MORGAN AND MORECAMBE OFFSHORE WIND FARMS: TRANSMISSION ASSETS

The Applicants' response to Hearing Action Points due at Deadline 1

Document Reference: S_D1_5

Figure 1: Illustrating examples of how consultation has been taken into account in the BRAG (Black, Red, Amber, Green) process to refine the onshore cable corridor

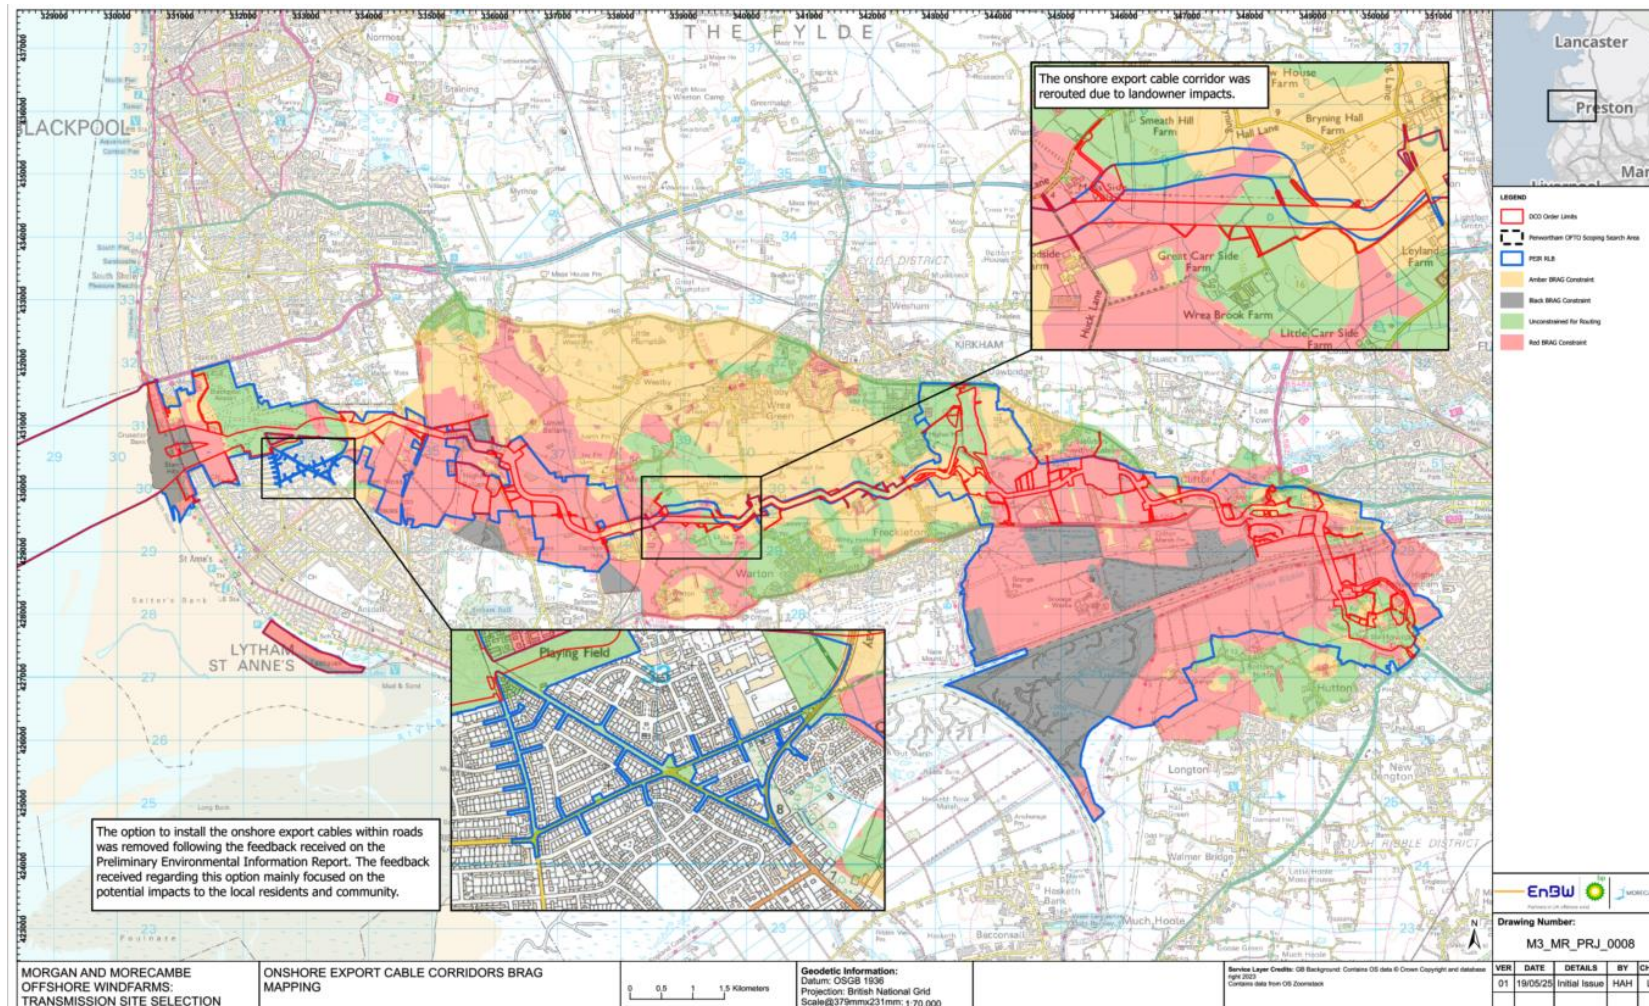
Hearing Action Point (HAP)	Agenda item	For whom	ExA Question	Applicants' response
				<div>Evidence Plan Process Consultation with statutory bodies</div> <p>Appendix A, provides a figure illustrating example(s) of how consultation feedback has been taken into account when refining the onshore cable corridor route. The examples in the figure highlight:</p> <ul style="list-style-type: none"> the removal of the option to lay cables in the public highway based on local residents and community feedback; and re-routing the onshore export cable corridor into areas with greater proportions of red constraints to accommodate landowner feedback. <p>The Applicants can confirm that the Black Red Amber Green (BRAG) appraisal for the onshore cable corridor did not include Green Belt as an assessment criteria. The constraints used in the BRAG criteria can be found in Table 4.14 and 4.18 of Volume 1, Annex 4.3: Selection and Refinement of the Onshore Infrastructure (AS-028).</p> <p>Paragraph 5.11.2 of NPS EN1 states that <i>'The fundamental aim of Green Belt Policy is to prevent urban sprawl by keeping land permanently open; the essential characteristics of Green Belts are their openness and their permanence.'</i> The onshore cable corridor, once installed, will be buried for its entire length maintaining the openness of the Green Belt. Therefore, the Applicants considered that there would be no impact to the fundamental aim of Green Belt Policy from the underground cables and therefore Green Belt was not included in the BRAG assessment criteria for the onshore cable routing for the Transmission Assets.</p> <p>The Applicants can confirm that Green Belt land was considered within the BRAG Assessment of onshore substation search zones and onshore substation options (Table 4.7 and Table 4.10 of Volume 1, Annex 4.3: Selection and Refinement of the Onshore Infrastructure (AS-028)), under the 'Planning policy and future development potential' category.</p> <p>Locations for onshore substation siting that were within identified Green Belt were assessed as an amber appraisal rating: "Located within the Green Belt and / or Area of Separation and proposal for further development or existing planning applications".</p> <p>The Applicants assert that the assignment of Green Belt land as 'Amber' is correct for the purposes of the onshore substation site selection process, and aligns with National Planning Policy Framework (NPPF) policy Section 13 – 'Protecting Green Belt</p>

- 2.1.1.1 The Applicants have provided Figure 1, illustrating an example of how consultation has been taken into account in the BRAG (Black, Red, Amber, Green) process to refine the onshore cable corridor.

Plate 2.1: Indicative construction programme for a sequential construction scenario including the four-year gap with Morgan Offshore Wind Project: Transmission Assets constructing first followed by Morecambe Offshore Windfarm: Transmission Assets

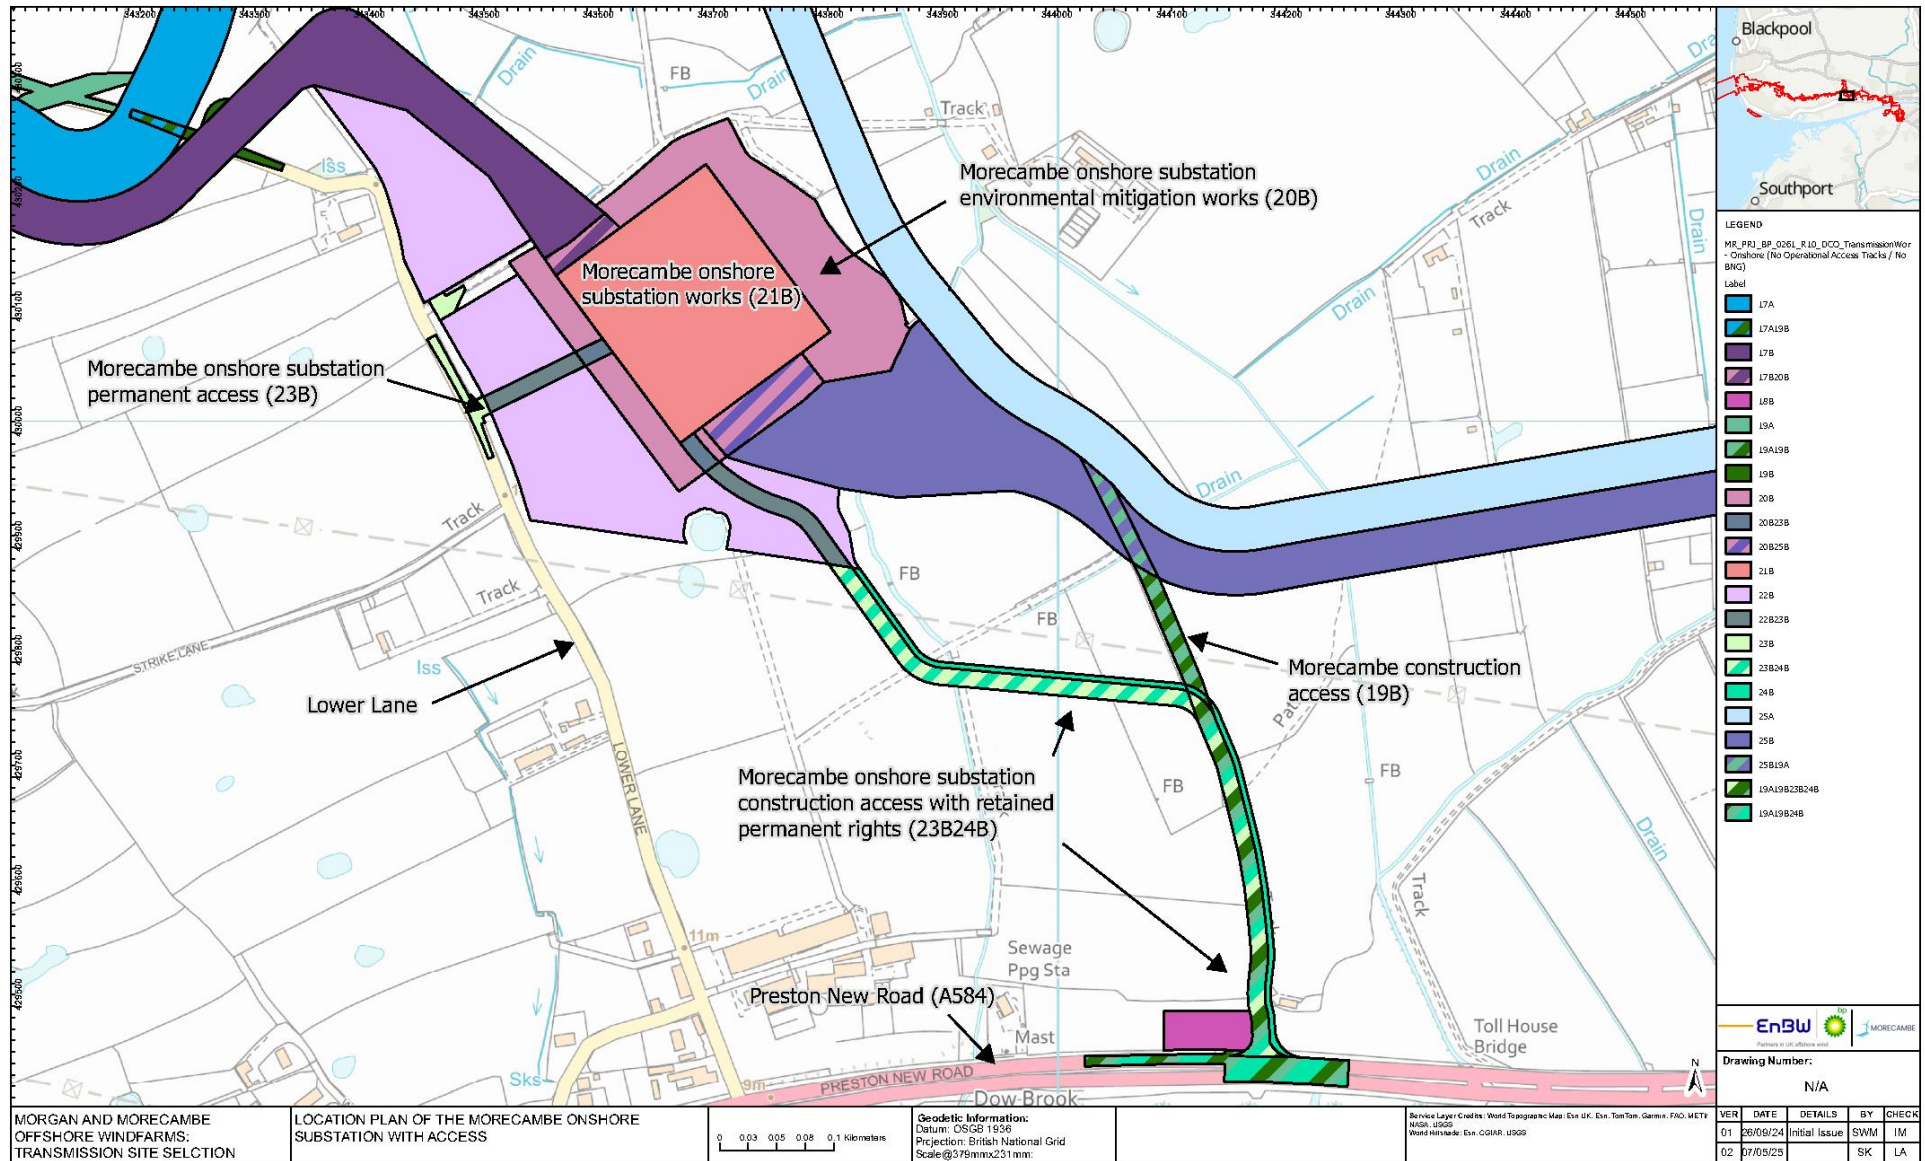
ISH1_24	5(c)	Applicants	Provide an indicative programme which shows sequential construction with a 4 year gap, to be included in any update to the project description chapter.	The Applicants have provided the indicative programme showing the sequential construction with a 4 year gap below in Appendix B – Applicants' response to ISH-24 below.
ISH1_25	5(d)	Applicants	Explain in outline terms how the applicants have sought to avoid potential environmental and community impacts in the co-ordinated design with regard to the approach taken to the number and location of the proposed substations, along with policy justification.	The number of the proposed substations is driven by the fact that each generating station requires its own dedicated onshore substation, so the Transmission Assets comprise two onshore substations. The need to maintain independent deliverability as a result of electrical separation means a single larger joint onshore substation (i.e. only one onshore substation for both projects) is not a suitable option (see ISH1_12). One onshore substation for both projects was also not recommended within the HND which noted that each project should have an electrically separate connection (which requires each project to have its own onshore substation). The necessary electrical independence of the projects means that a separate onshore substation is required for both the Morgan

- 2.2.1.1 For clarity the Applicants have provided two plates illustrating the sequential construction scenario programme with up to the four-year gap. Plate 2.2 assumes Morgan OWL is constructed first followed by Morecambe OWL, and **Error! Reference source not found.** assumes Morecambe OWL is constructed first followed by Morgan OWL.
